Oliver/Solie
CUSTOM HOME
OFF-SITE

AVALON "A"

FIRST FLOOR PLAN

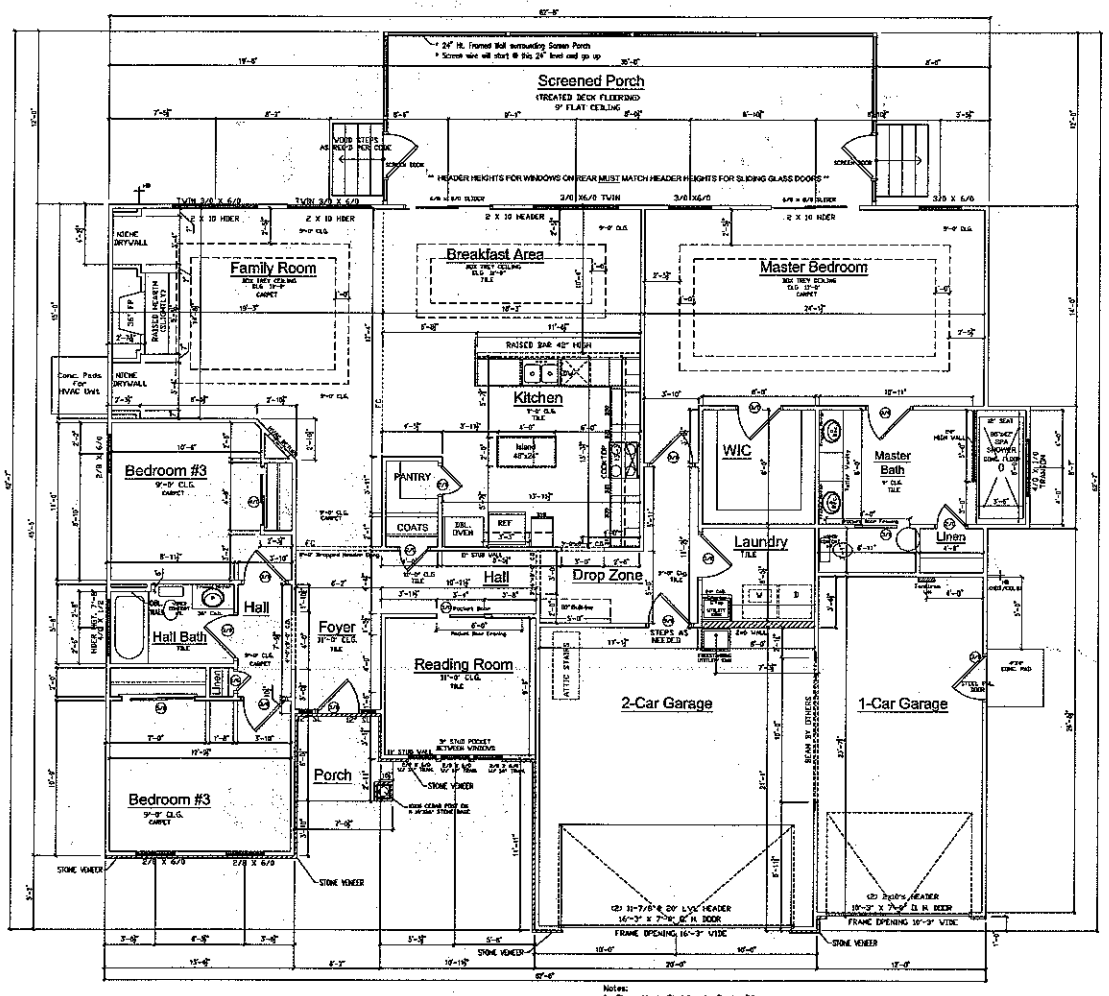
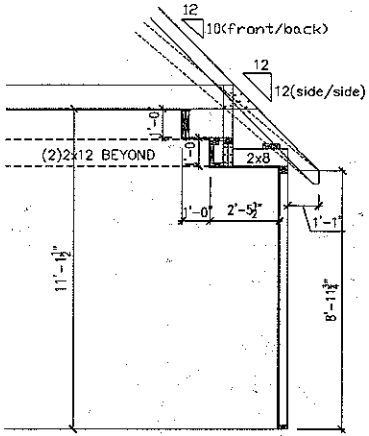
SHOWER NOTES:
* Delete curb at Master Spa Shower. The concrete floor will be recessed with a gradual slope as the slab is poured. The "HIGH" point will be near the shower doorway
* Double Rec. Niche in shower (location T.B.D.)

Notes:
1. Owise Mesh Shelving in Pantry/Linens
2. Total Slide Shelving in Closets
3. Slightly raised hearth. Check with Superintendent for exact height.
4. Specifics regarding location of support bars in bathrooms to be discussed with Superintendent at Plan Review.
5. Delete toilet paper holder in both Baths.
6. Header heights for windows on rear must match header heights for sliding glass doors.
